GULF STATES UTILITIES COMPANY

December 12, 1983
RBG-16,543
File Code G9.5, G9.8.6.1

River Bend Station Units 1 & 2
Docket Nos. 50-458/50-459

Enclosed for your review are Gulf States Utilities Company's (GSU) responses to Draft Safety Evaluation Report (DSER) open items identified by the Nuclear Regulatory Commission's (NRC) Reactor Systems Branch (RSB). In addition, the Licensing Review Group-II (LRG) positions 1-13-RSB and TMI Action Plan Requirements requested in a NRC letter to GSU dated April 21, 1983 are discussed herein. Attachment 1 is a summary listing of the items discussed in Attachment 2. Attachment 2 provides the response and reference material for each item. Where indicated, these responses will be provided in a future amendment to the FSAR.

FIGURE 5.4-13

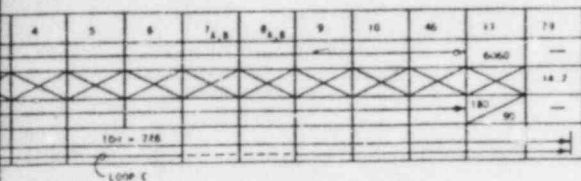
The response to Question 440.28 requires additional clarification. NPSH values required at 3 ft. above mounting flange (typical test) are shown in figures 6.3-3, 6.3-6 and 6.3-7 for HPCS, LPCS and RHR pumps. Are these values derived from plant-specific tests conducted for RBS pumps? What is meant by "typical test"?

Describe in a detailed and consistent manner the NPSH required and the NPSH available for the ECCS pumps. Revise FSAR figures 6.3-3, 6.3-6 and 6.3-7 to show both NPSH required and NPSH available.

The relationship between NPSH available values in Section 6.3.2.2 and the NPSH required values shown on Figures 6.3-3, 6.3-6, and 6.3-7 for the ECCS pumps is clarified in revised Section 6.3.2.2 and Figure 5.4-13. This discussion is consistent with LRG-II position 7-RSB.
